COMMONWEALTH of VIRGINIA

February 26, 2016

MEMORANDUM

To: All Holders of the Virginia Department of Transportation's 2008 Road and Bridge Standards

VDOT	
ROAD AND BRIDGE STANDARDS	
REVISION DATE	SHEET 1 OF 1
02/16	1312.80

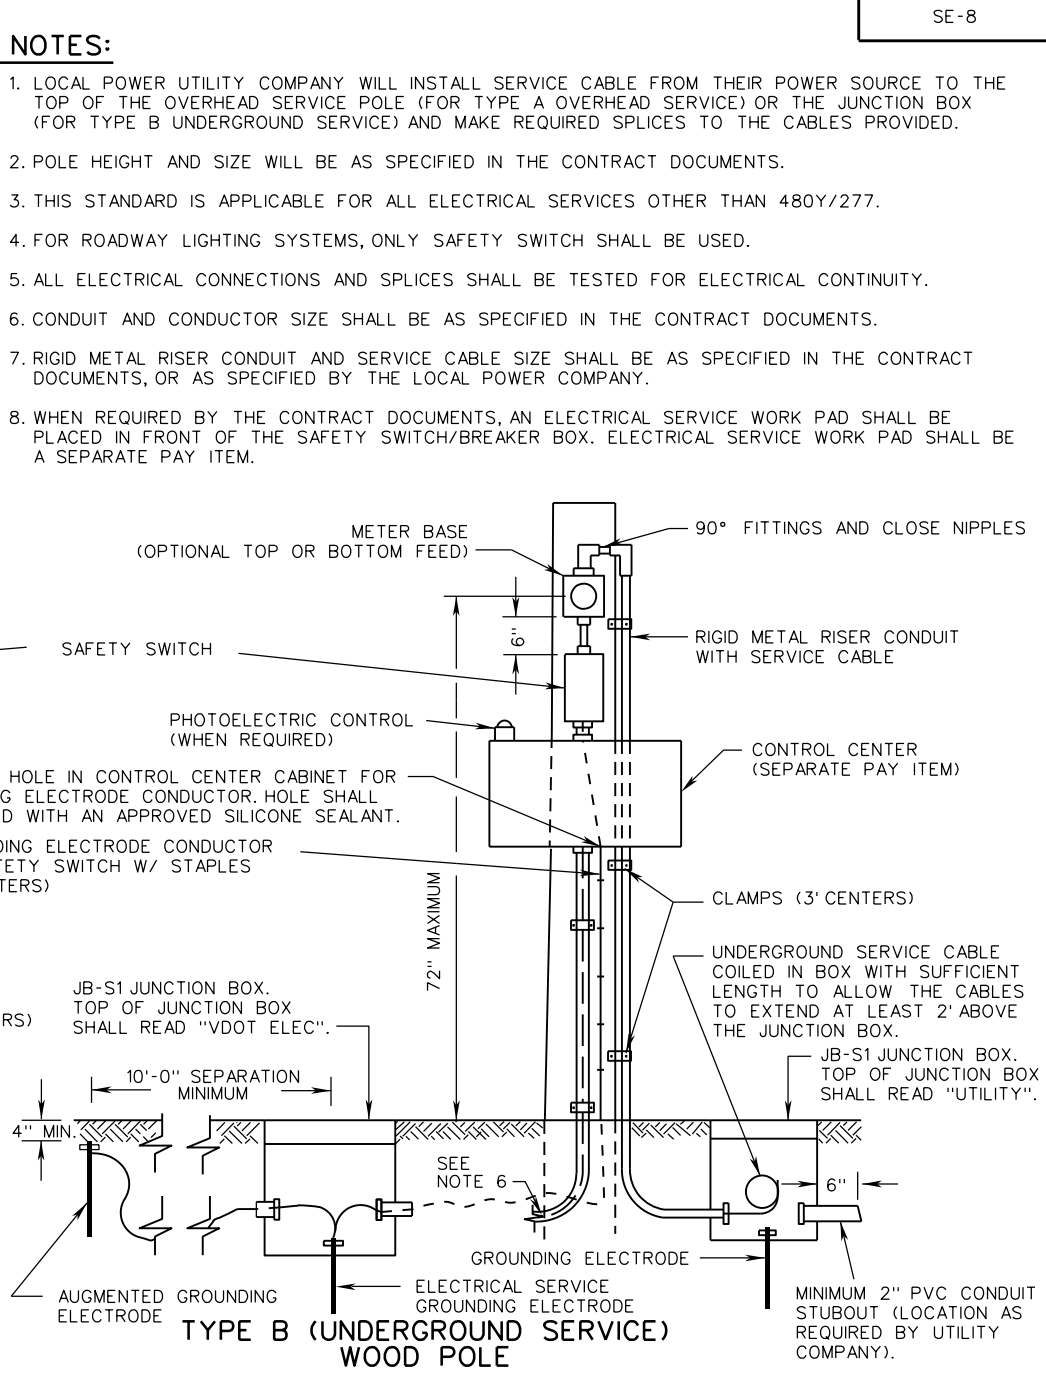
1312.80	IIS13_1312_80	SE-8	ALL NOTES REVISED. CLARIFIED SERVICE THIMBLEYE DRAWING. ADDED PHOTOELECTRIC CONTROL. ADDED HANDHOLE. SEVERAL LABELS CHANGED. GROUNDING ELECTRODES CHANGED IN DRAWING.

1312.91

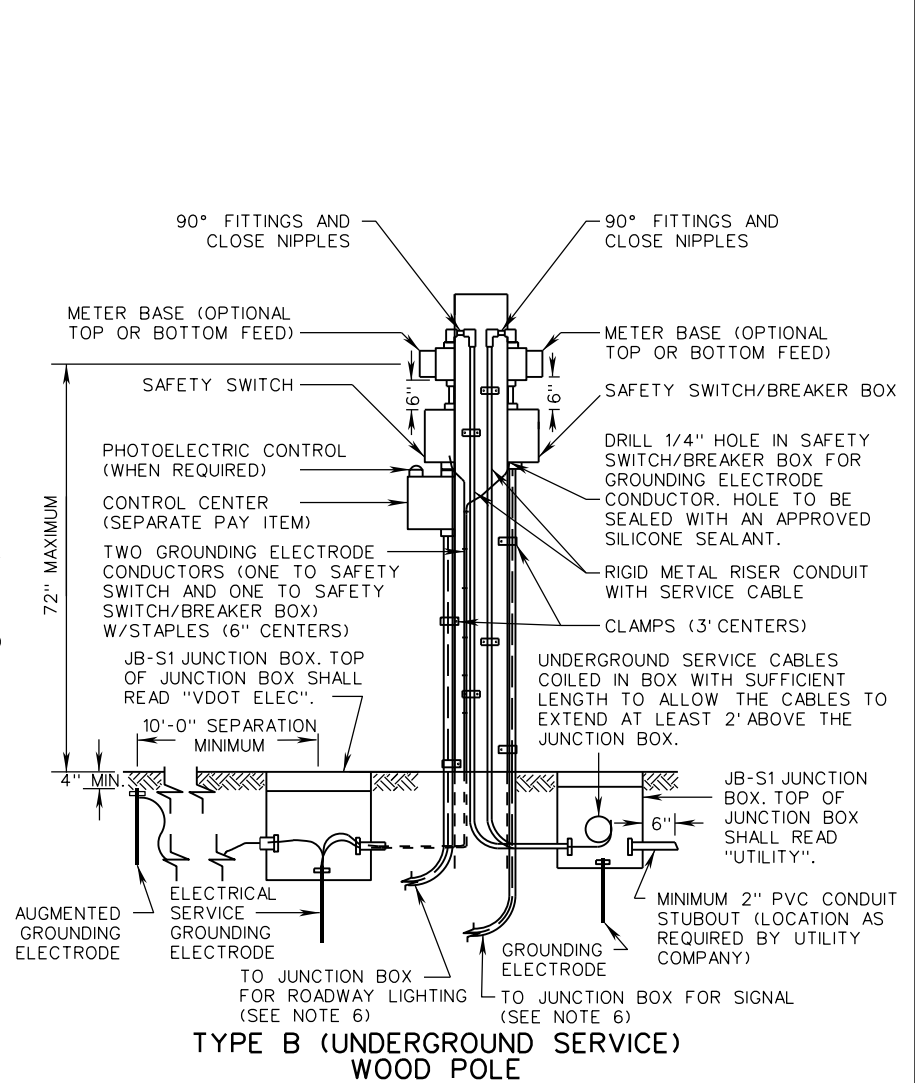
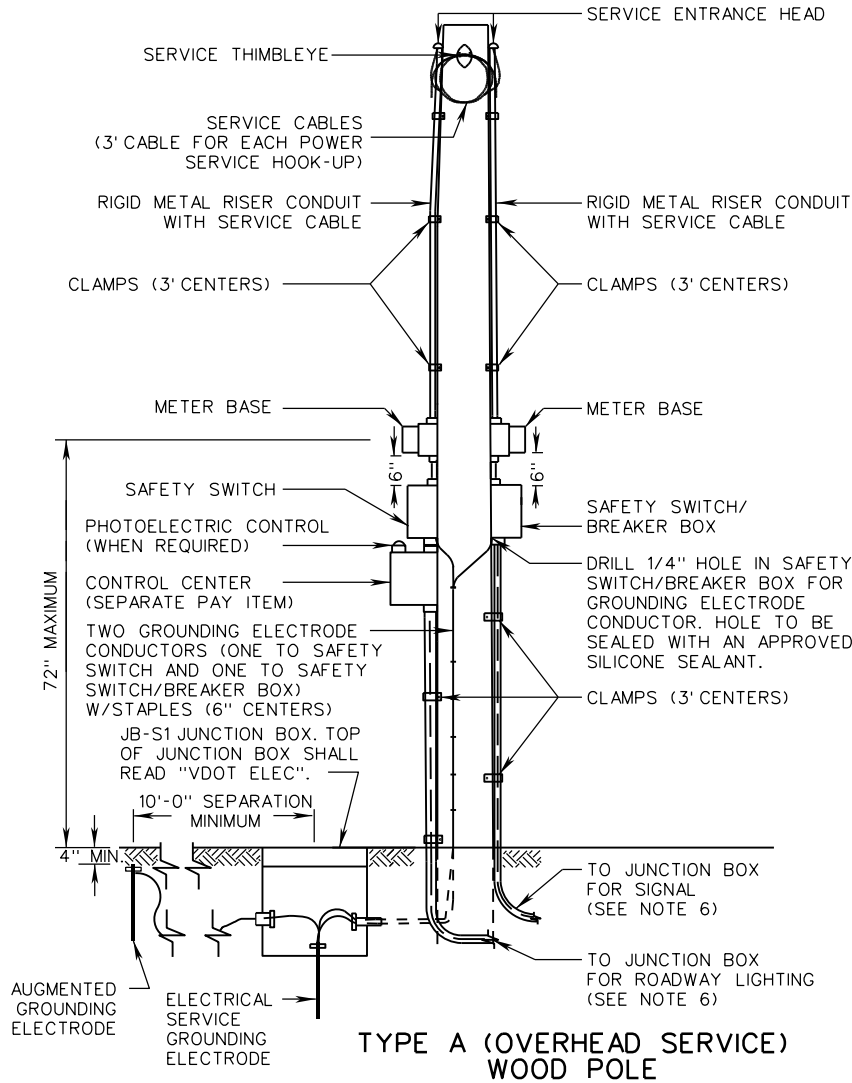
<u>PAGE</u>	<u>INTERIM</u>	<u>STANDARD</u>	<u>REVISION</u>
1312.90	IIS13_1312_90	SE-9	ALL NOTES REVISED. SEVERAL LABELS CHANGED. BASE OF THE POLE REVISED. CLARIFIED CONDUIT RUN. GROUNDING ELECTRODES CHANGED IN DRAWING.
1312.91	IIS13_1312_91	SE-9	ALL NOTES REVISED. SEVERAL LABELS CHANGED. BASE OF THE POLE HAS BEEN REVISED. CLARIFIED CONDUIT RUN. GROUNDING ELECTRODES CHANGED IN DRAWING. REVISED SERVICE ENTRANCE FOUNDATION DETAIL.
1313.10	IIS13_34	SE-10	ALL NOTES REVISED. SEVERAL LABELS CHANGED. CLARIFIED CONDUIT RUN. GROUNDING ELECTRODES CHANGED IN DRAWING.
1313.20	IIS13_1313_20	SE-11	ALL NOTES REVISED. SEVERAL LABELS CHANGED. BASE OF THE POLE HAS BEEN REVISED. CLARIFIED CONDUIT RUN. GROUNDING ELECTRODES CHANGED IN DRAWING. ADDED SEPARATE DETAIL FOR CONNECTION OF CONDUIT TO METER BASE.
1313.21	IIS13_1313_21	SE-11	ALL NOTES REVISED. SEVERAL LABELS CHANGED. BASE OF THE POLE REVISED. CLARIFIED CONDUIT RUN. GROUNDING ELECTRODES CHANGED IN DRAWING. WATERPROOF SPLICE BOX ADDED. SEPARATE DETAIL ADDED FOR CONNECTION OF CONDUIT TO METER BASE.

1320.14

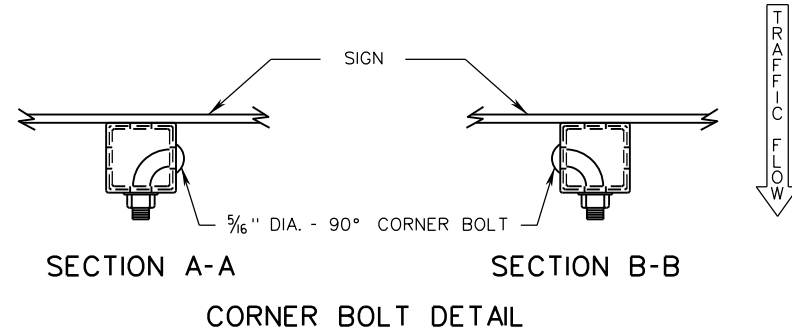
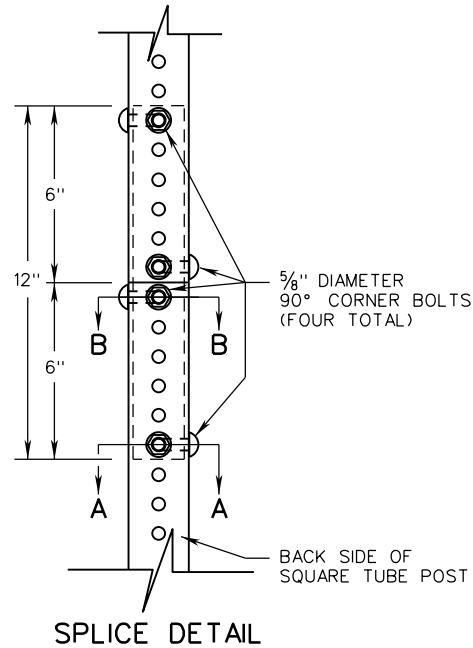
<u>PAGE</u>	<u>INTERIM</u>	<u>STANDARD</u>	<u>REVISION</u>
1320.14	IIS13_1320_14	WSP-1	NEW SHEET WITH SQUARE TUBE POST DESIGN TABLE.
1320.15	IIS13_1320_15	WSP-1	NEW SHEET WITH SQUARE TUBE POST SPLICE DETAIL.
1340.12	IIS13_1340_12	PM-10	CORRECTED THE ERADICATION SQUARE FOOTAGE FOR THRU ARROWS.
1340.16	IIS13_1340_16	PM-10	CHANGED THE DESCRIPTION OF THE YIELD LINE TRIANGLES TO MATCH THE PAY ITEM DESCRIPTION.
